Re: Pole-Safe[®] Skirt Model SPMKDN-2S

Bulletin 3: Feb 2011

Pedestrian Pole Skirts for Pole-Safe

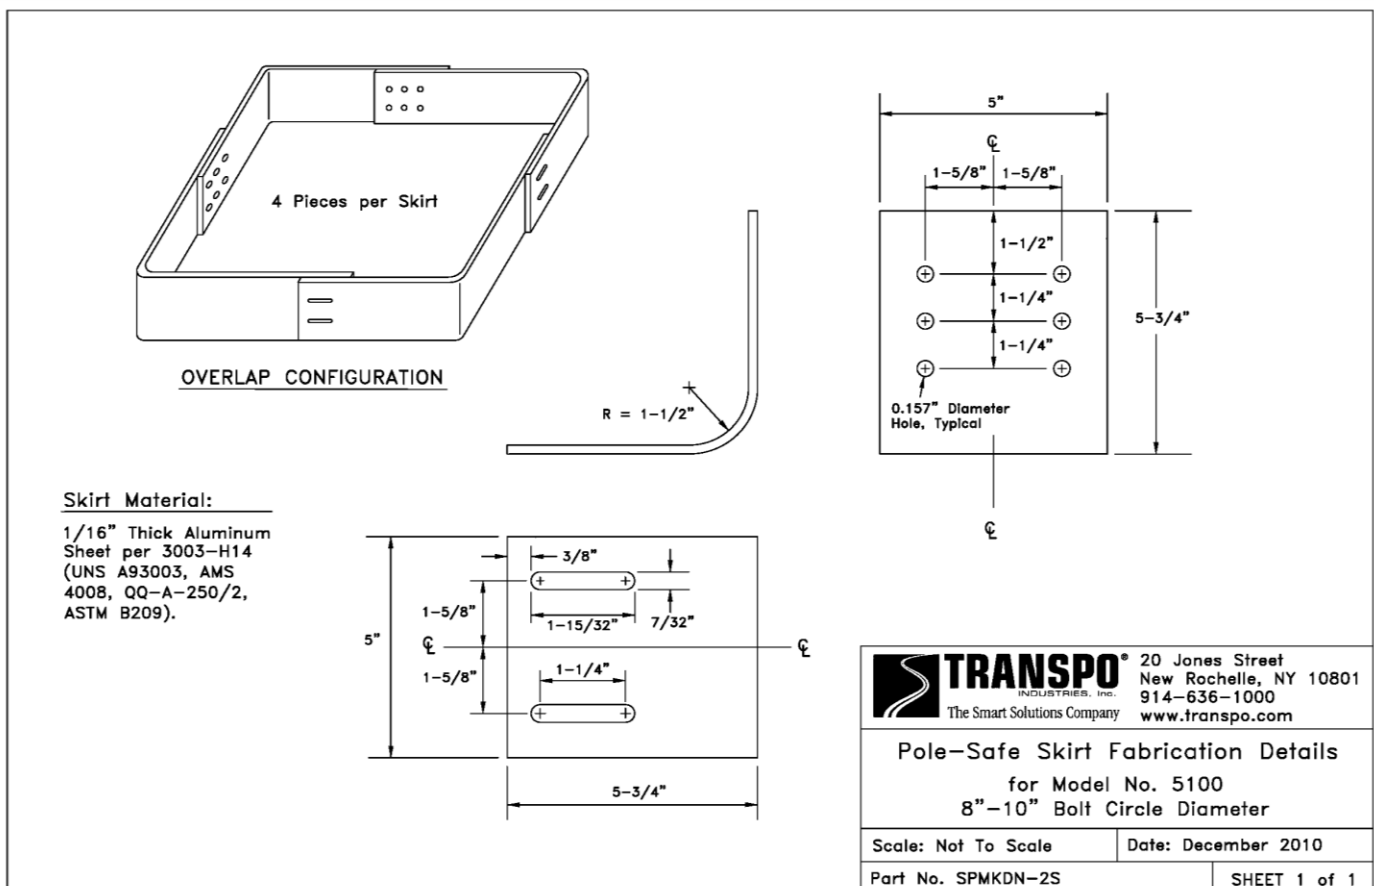
Recently it was brought to our attention by our new Maryland Safety Distributor Traffic Systems & Technology that the current Maryland State Highway specification for Pedestrian Traffic Poles on Transpo's Pole-Safe breakaway system calls for an 8" bolt circle. Contractors had been "trimming" our 10"- 15" B.C. skirt for use with this new, smaller pedestrian pole.

To accommodate the requirements in Maryland, we are now offering an 8"- 10" four piece adjustable skirt for use with our Pole-Safe Model SPM-5100 with Type B Ferruled Anchors, which is Maryland's State Standard Specification.

NOTE: The skirt is sized for the height of the 5100 Pole-Safe Coupling. It measures 5" from the foundation to the top of the coupling. There is approximately a 1/16" air slot at the top of the skirt.

The part number for this Ped-Pole skirt is SPMKDN-2S and the list price is the same as the 10"- 15" skirt.
